GOVERNMENT AIRCRAFT FACTORIES

SERVICE BULLETIN

SUBJECT: REVISED AIRSPEED INDICATOR LIMIT MARKING (V_Y) FOR
N24A SERIES AIRCRAFT

NMD-39-2

**V_y Placard Affixed as Shown
(RH Similar)
Figure 1**

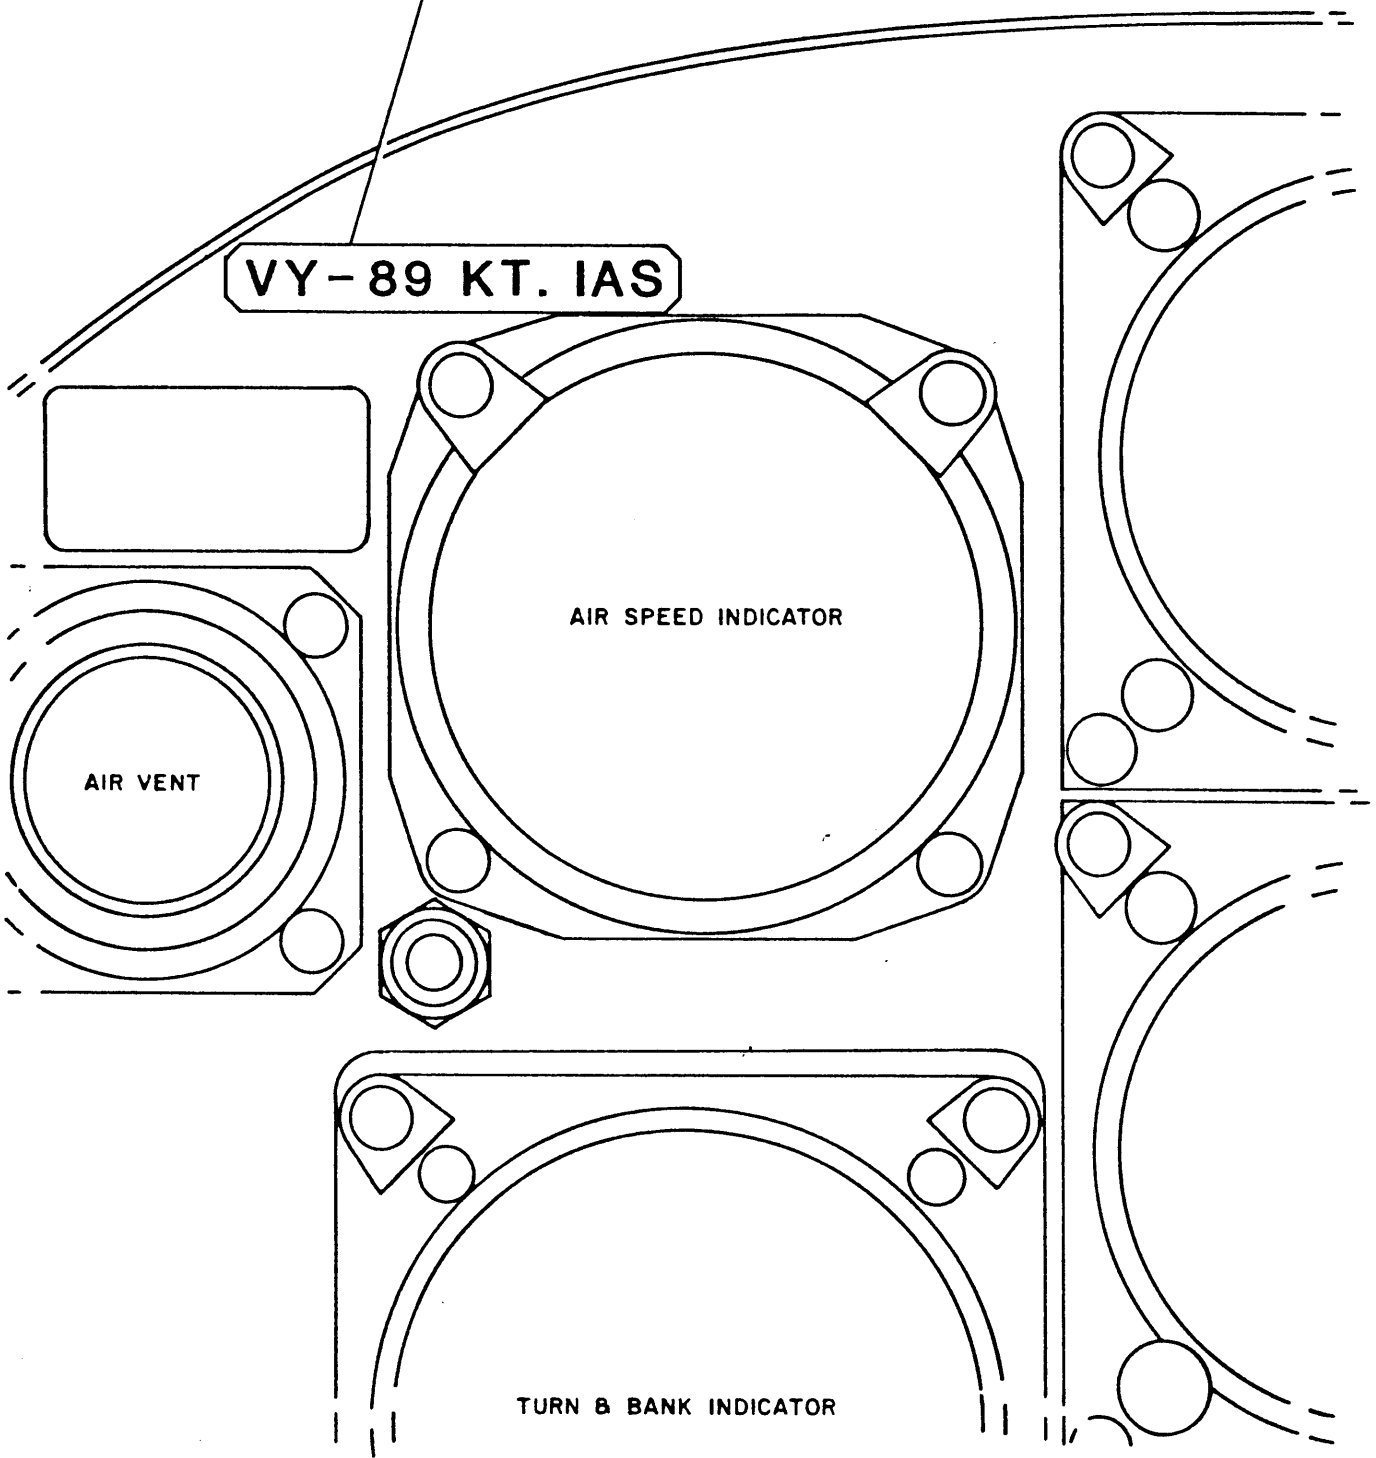
- A. Affix a placard with the caption, as shown in Figure 1, adjacent to the LH ASI in the location shown.
- B. When an optional ASI is fitted in the RH instrument panel affix a similar placard as in item A above.

PLACARD (I/N-00-913)
ALTERNATIVE -
METAL LABEL OR EQUIVALENT
(SILVER OR WHITE LETTERS ON BLUE BACKGROUND)
